# BEFORE THE BOARD OF PATENT APPEALS AND INTERFERENCES

Application Number: 10/821,766

**EXAMINER'S ANSWER**

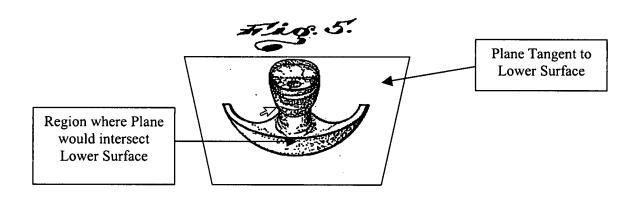
Applicant argues that the examiner's interpretation of a plane tangent to a lower surface, as shown in the attached figure, is unreasonable and contrary to common sense, and that the only reasonable interpretation is that argued by applicant. However, the examiner disagrees. Applicant's claim language is to such a broad extent that the applied art could clearly meet such limitations since no limiting language has been claimed to prevent such an interpretation. The line shown in the examiner's attached figure intersects a plane that would extend normal to the plane of the page, and would be tangent to at least part of the lower surface of the blade; thus meeting the claim language. It is the position of the examiner that the applicant is being unreasonable in suggesting that one skilled in

Applicant assert that in order for the examiner to be consistent, the examiner must be able to draw the tangent plane in every view of the figure disclosed by the applied art (namely figure 5). However, the examiner disagrees. It is not a requirement for a claim to be anticipated by prior art for such a condition to exist.

None the less, such an angled plane could be drawn as in the below attached figure.
